**PARTS & SERVICE
NEWS**

REF NO.	AT02114
DATE	Oct. 21, 2002

SUBJECT: REPAIR PROCEDURE OF WATER LEAKS FROM CYLINDER HEAD U-PLUG ON SA(A)6D170

PURPOSE: To introduce modification procedure to repair or to prevent occurrence of water leakage by corrosion of the U-plug of the cylinder head of the S (A or AA) 6D170 engines

Fig. 1

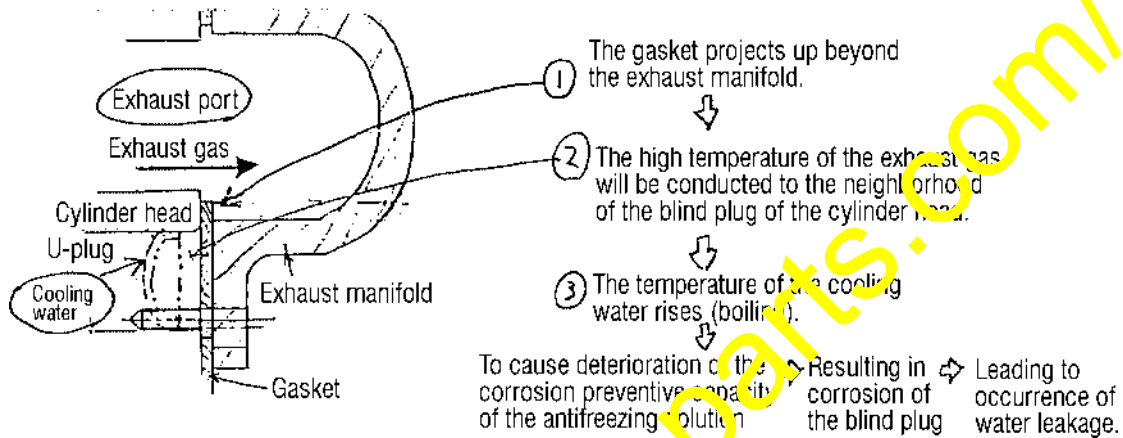
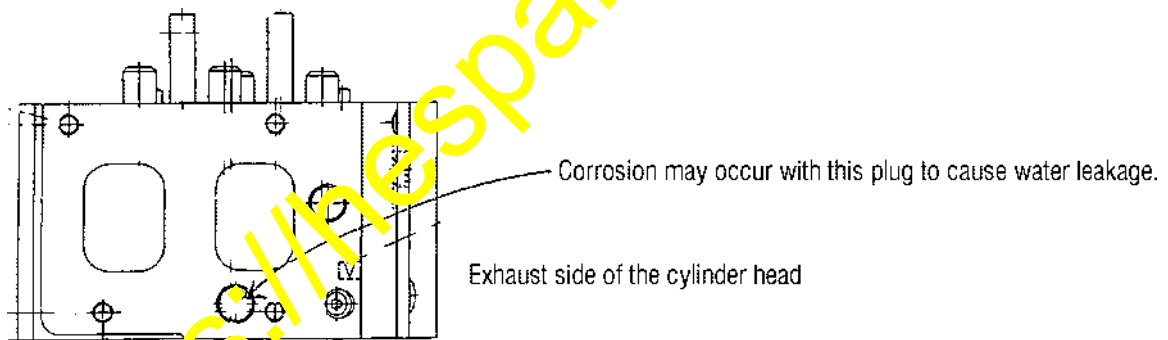
- ① With the S(A or AA)6D170-1 type engines, since the exhaust manifold will be installed below the cylinder head and below the top edge of the exhaust manifold gasket when it is being assembled, the gasket may project up beyond the exhaust manifold.
- ② By this structure, the high temperature of the exhaust gas will be conducted through the gasket to the blind plug of the cylinder head.
- ③ Therefore, the temperature of the cooling water in the neighborhood of the blind plug rises to cause deterioration (by boiling) of the corrosion preventive capacity of the antifreezing solution thus resulting in corrosion of the blind plug → and in occurrence of water leakage.

Fig. 3

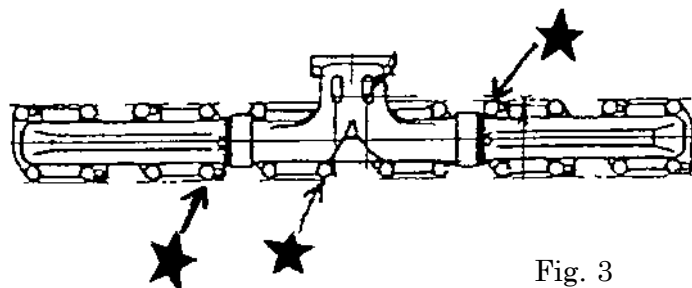
Up to now, the mounting bolt holes for the exhaust manifold were all $\phi 15$ holes while the mounting bolt size was M12. Hereafter smaller holes will be made for the positioning purpose.

(Smaller hole of $\phi 13.5$: At 3 places marked ★ in the drawing below.)

Fig. 4

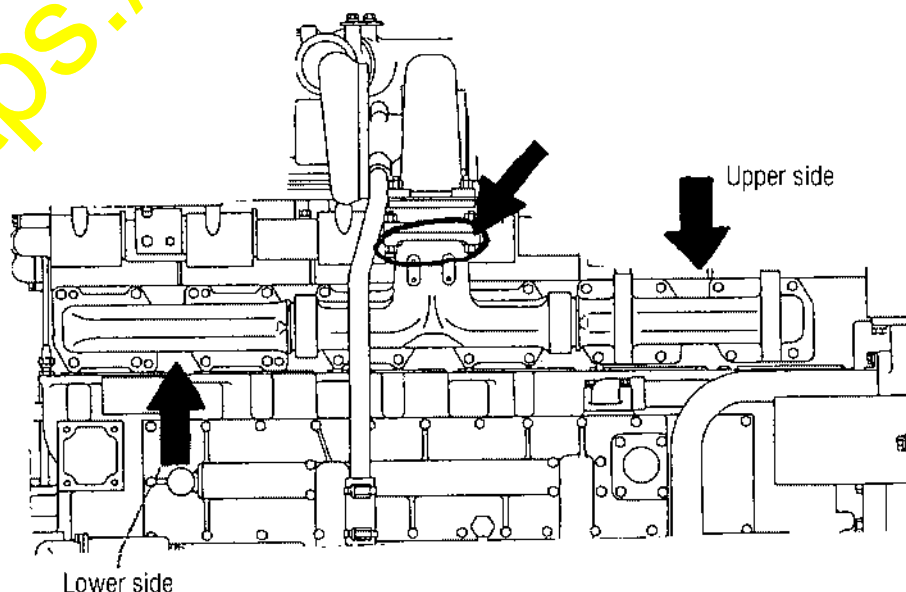
Since the part number of the exhaust manifold is being stamped or embossed at the position shown in the drawing below, identify if the exhaust manifold is of before the modification or after the modification by the aforementioned part number.

Fig. 5

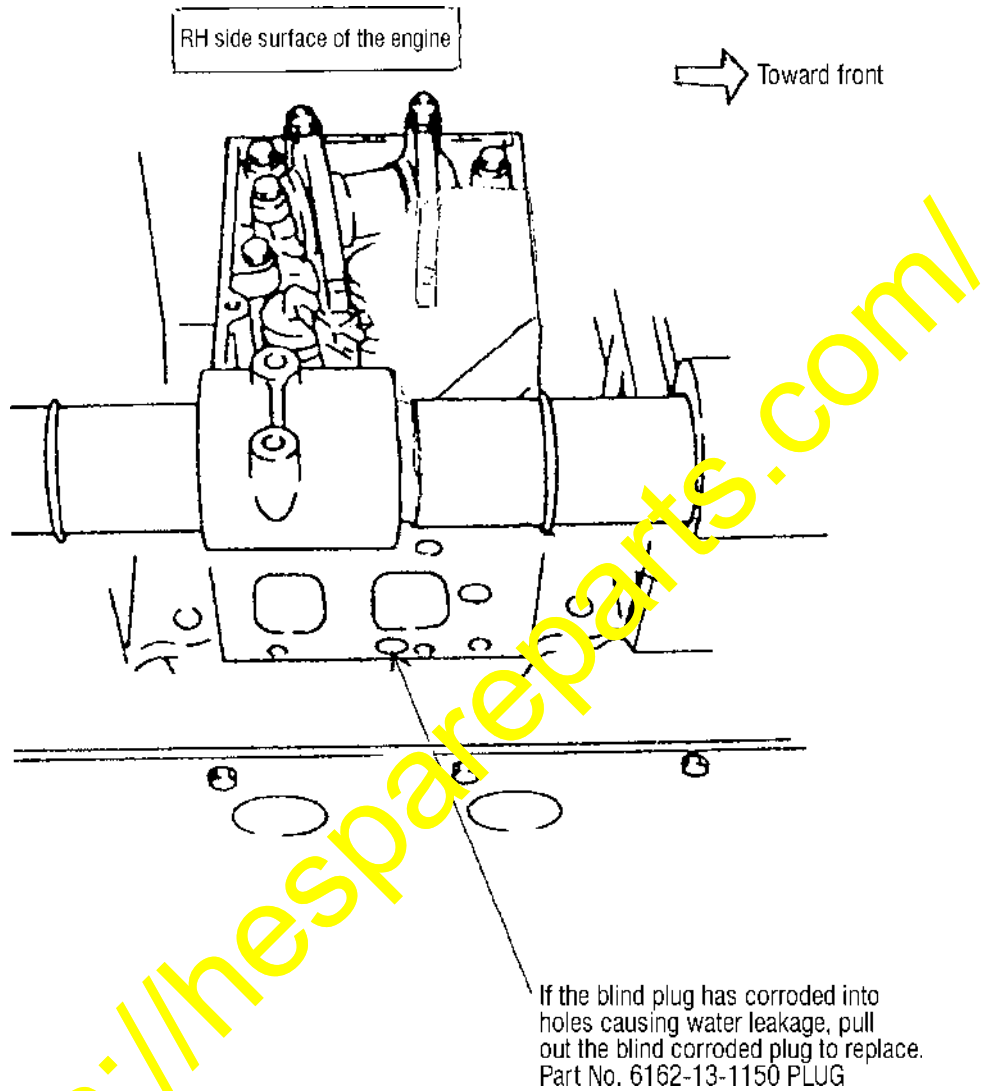
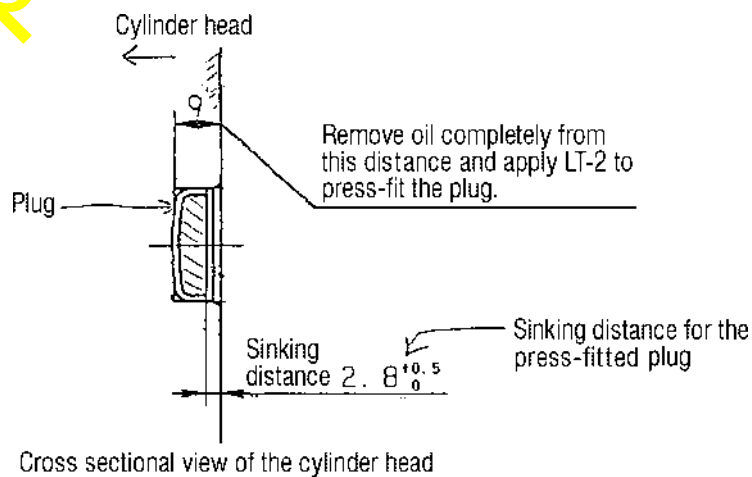
- (2) If water leakage has occurred through the blind plug being positioned on the mounting surface on the cylinder head for the exhaust manifold, make the following modification to repair the water leakage.
Refer to the Shop Manual regarding the disassembly and re-assembly procedure.

Fig. 7

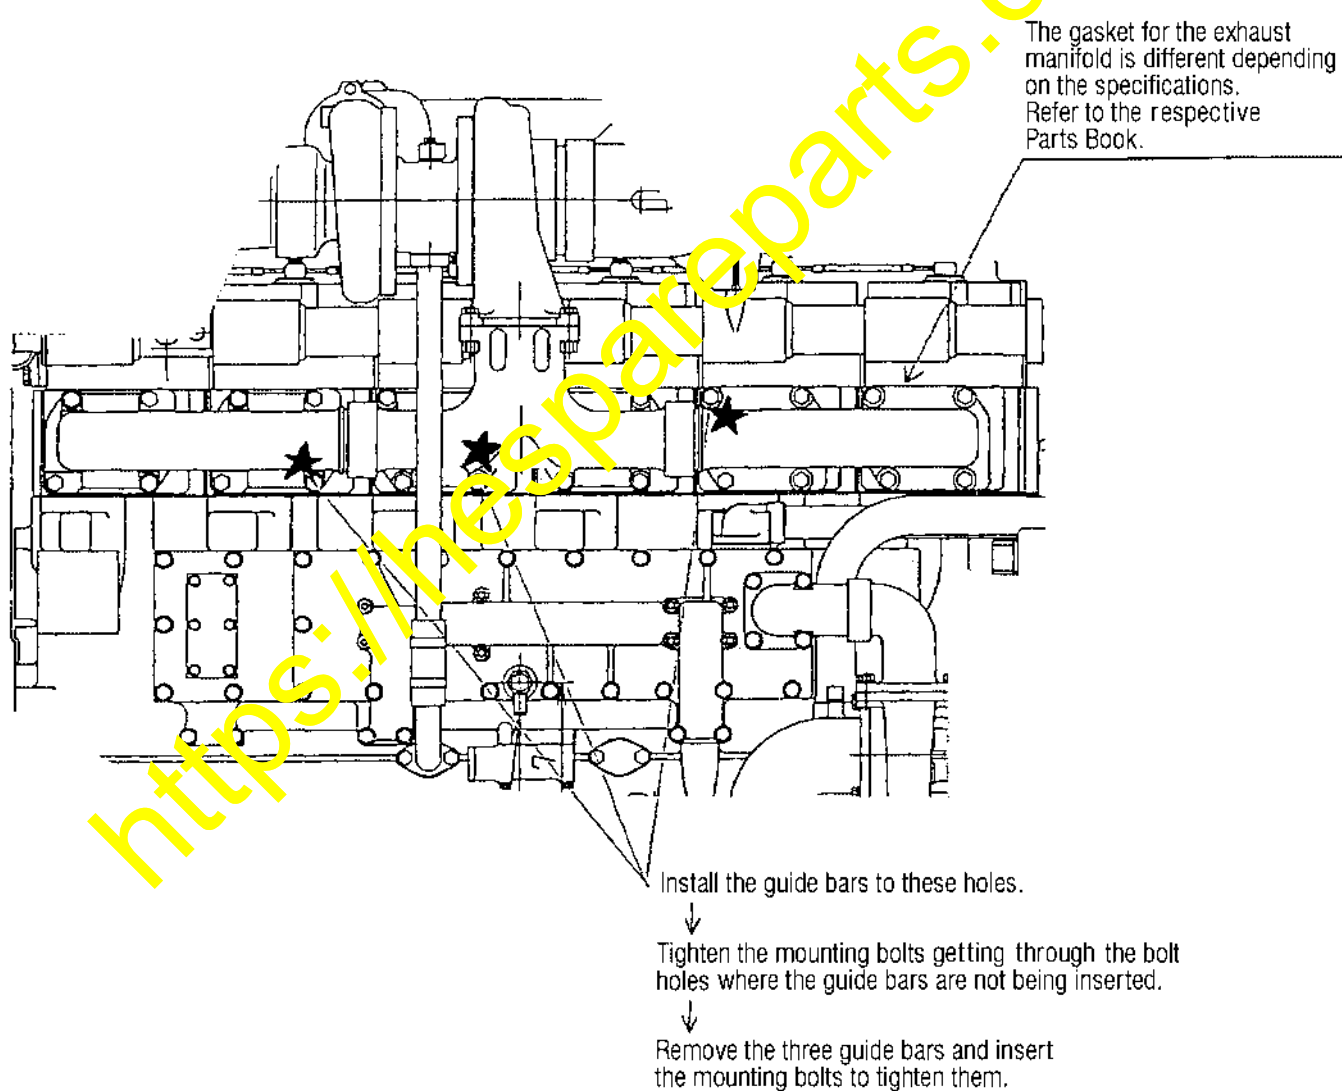
- a) Make 3 pieces of the guide bars as per Fig. 8
(3 guide bars are necessary for one engine.)
- b) Install the prepared guide bars into the 3 sections (Marked ★) shown in the drawing below and, after that, mount the exhaust manifold ass'y by tightening the mounting bolts getting through the bolt holes where the guide bars are not being inserted.
- c) Remove the three guide bars and insert the mounting bolts to tighten them.
